**Diesel After-Sales Service**

# **Service Bulletin**

# **RTA-28**

# Improvement of the Engine Control System

# 1.1.1. Existing Execution with Valve 49HH in Valve Group "G"

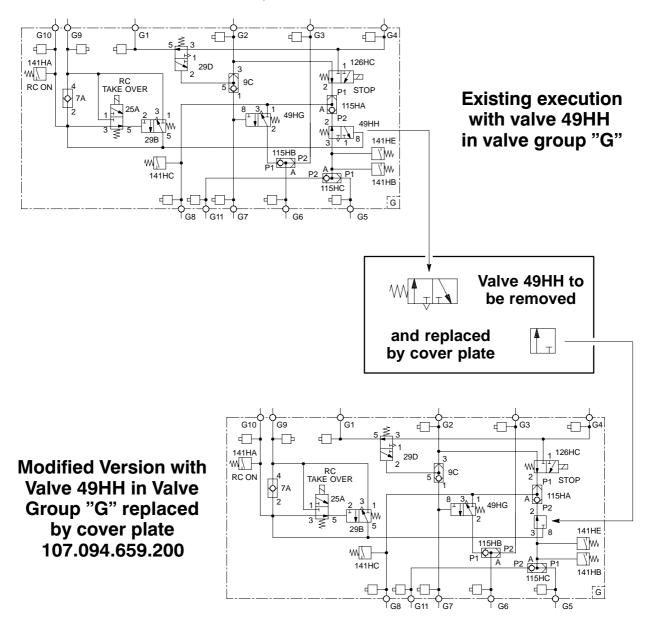
When running the engine from the "Local Control" stand there is **no pressure on port No. 8 of valve 49HH** as shown on the diagram of valve group "G" above.

If the engine is running in the wrong direction connecting point G11 is under pressure. In case one or more of the reversing servomotors are not in the correct endposition the connection G5 is under pressure. The pressure signal either from G5 or G11 is transmitted through to ports 3-2 of valve 49HH which inturn influences the fuel interlock.

The engine internal fuel interlock for the direction of rotation safeguard is not active if the engine is in "Remote Control" mode (valve 49HH is activated). Under certain circumstances, such as defective control valves in combination with a failure of the crosshead oil pump, an undesired reversing of the engine may result.

To ensure that the fuel is cut-off in all necessary cases the fuel interlock should remain activated at all times, i.e. with the engine in "Local Control", "Control Room Control" and "Bridge Control" mode. This can be achieved with the modification shown in Paragraph 1.1.2. or 1.1.3.

# 1.1.3. Modification for Engines WITH Engine Driven Generator

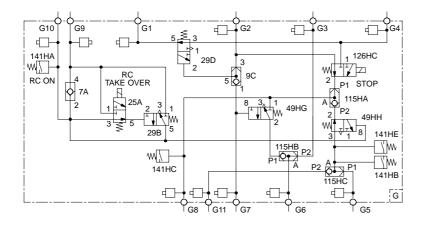
For plants **with engine driven generators** it is possible to carry out the modification in two steps:

a) In principle the same modification as mentioned in Paragraph 1.1.2. can be carried out as a first step. In this case the rotation direction safeguard will remain actuated at all times, also in the remote control mode, and in this way there is a better safety margin against wrong manoeuvring. However, if the main lubricating oil pump fails, a black-out can occur until the stand-by pump has built-up oil pressure again, which may take a few seconds.

We therefore recommend to modify the system according to paragraph b) directly, or as soon as possible if the system was previously modified according to paragraph a), in order to benefit from the additional safety measures against black-outs:

b) For plants with an engine driven generator the solution is to fit an additional solenoid valve 130HF (please refer to the sketch below and the fitting instructions on next page).

Existing execution with valve 49HH in valve group "G"

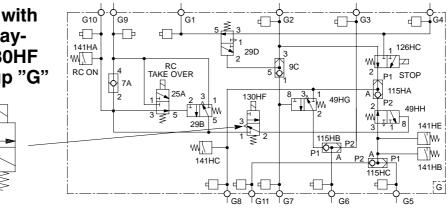
The valve 130HF prevents a blackout, which could occur in case of a pressure drop in the main bearing oil system until the stand-by oil pump is automatically put in service. In case the normal bearing oil pressure is not built up again within a few seconds the engine will be stopped by the safety system.

# Fitting Instruction for 3/2-Way-Solenoid-Valve 130HF

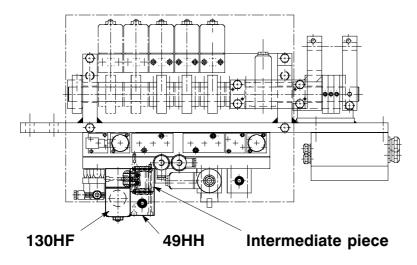
Valve 49HH to be temporarily removed

refitted onto infitted instead termediate piece 3/2-way solenoid valve 130HF can now be fitted to the side of the intermediate piece

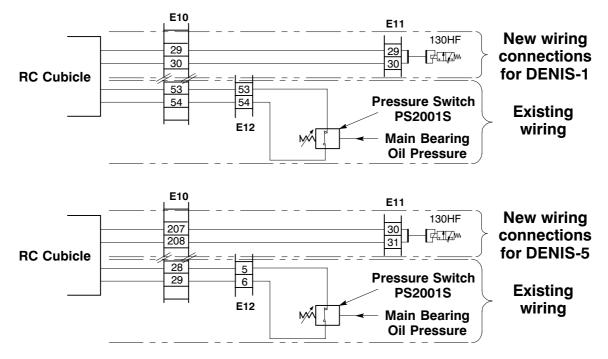
The solenoid valve 130HF will be energized as soon as the pressure switch PS2001S indicates a low main bearing oil pressure.

The 3/2-way solenoid valve is only required on engines which drive a generator.

As preparatory work the solenoid valve 130HF can already be wired with the junction box E11 and E10. Since the junction box E10 is the interface between DENIS and the Remote Control, the supplier of the remote control system should be contacted for further information regarding the connection between E10 and the remote control system.

**Please note:** The remote control system has to be **prepared** and **adapted** for the connection of the solenoid valve 130HF by the supplier of the remote control system.

# **1.2.1.** Existing Execution with Valve 49HG in Valve Group "G"

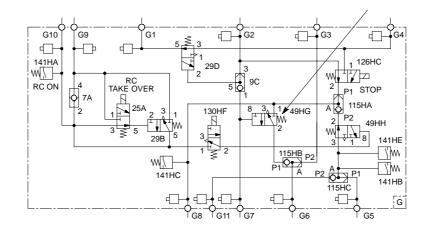
When running the engine from the bridge, from the control room or from the local control stand there is no control air pressure on port No. 8 of valve 49HG and the valve is in the same mode as drawn on the above diagram i.e. there is no connection between port No. 1 and port No. 2. When the engine is stopped and during reversing the fuel is cut-off by the Woodward governor or the electrical actuator (with electronic governor) via the fuel linkage.

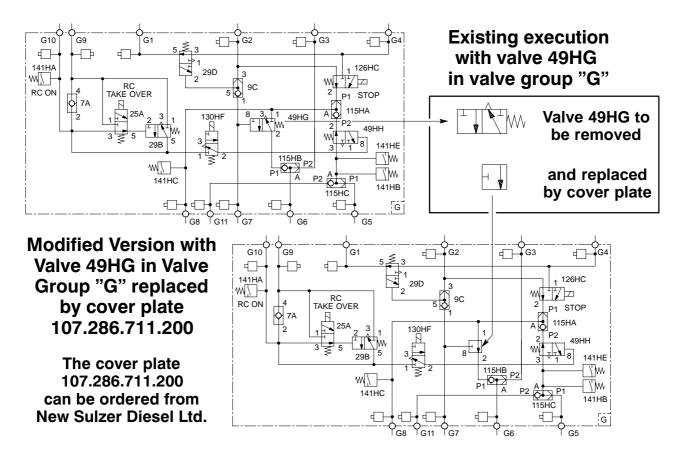
On engines with electronic speed controls, using electrical actuators to adjust the fuel linkage, valve 49HG **must** be removed and the cover plate 107.286.711.200 must be fitted instead.

The cover plate will now blind-off connection No. 8 and will join the connection No. 1 with connection No. 2 (please refer to the sketch below).

However, it was found that under the latter condition the stop lever 5.07 becomes inoperative and therefore it is necessary to carry out the above modification in order to be sure that the engine can also be stopped at any time with the stop lever.
